**ADDENDUM No. 1 TO ORIGINAL INVITATION TO BID**

**Bid No.: 5566-2019 Pineview Elementary School Standby Generator Replacement**

*Leon County Schools  
Project # 23-18-P-92  
Pineview Elementary School Standby Generator Replacement*

MFE Addendum #1  
4/1/2019

SHEET TITLE: ELECTRICAL DEMOLITION AND NEW WORK PLANS

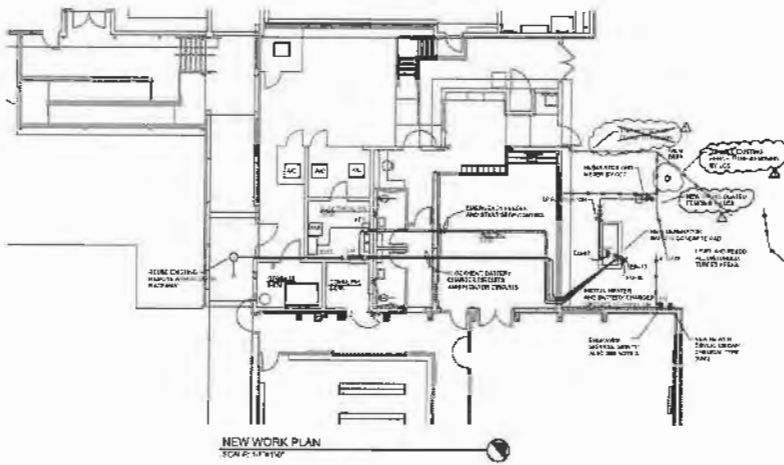
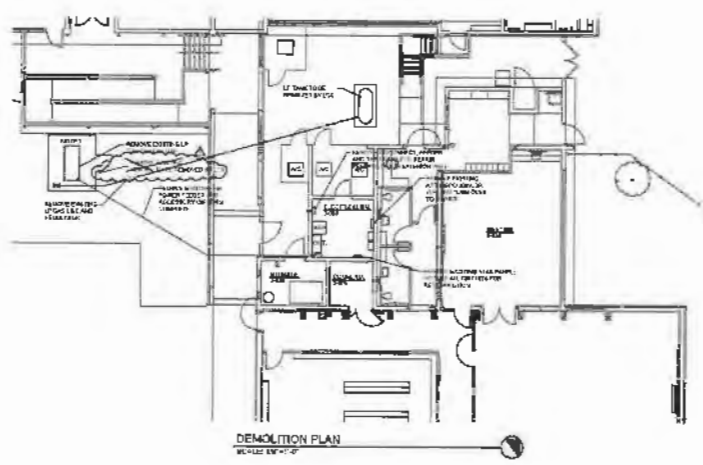
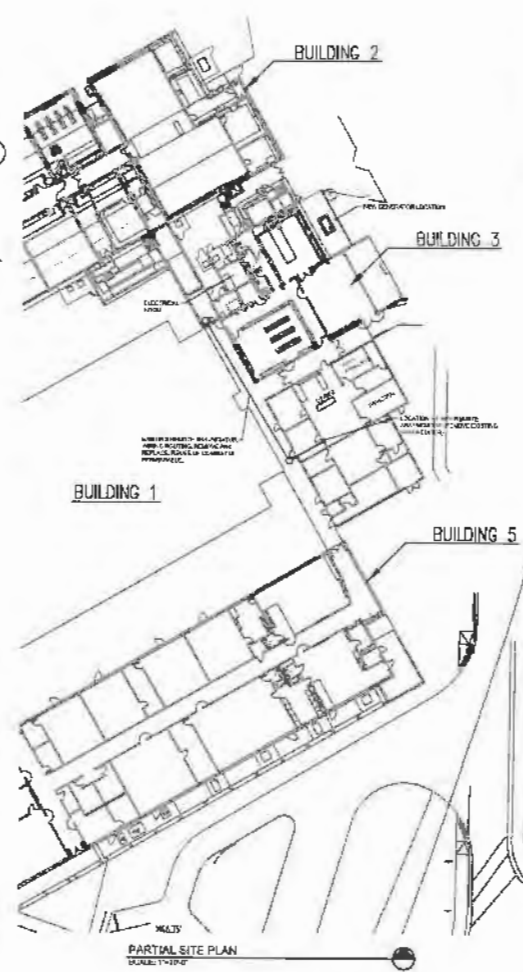
1. SPECIFICATIONS – SECTION 02381 CHAIN LINK FENCES AND GATES (LCS)  
Change – Specification section is for reference (no change to specification). All Chain Link Fences and Gates will be installed by the Owner.
2. DRAWING E2.0 – ELECTRICAL DEMOLITION AND NEW WORK PLANS  
Change – All Chain Link Fences and Gates will be installed by the Owner.
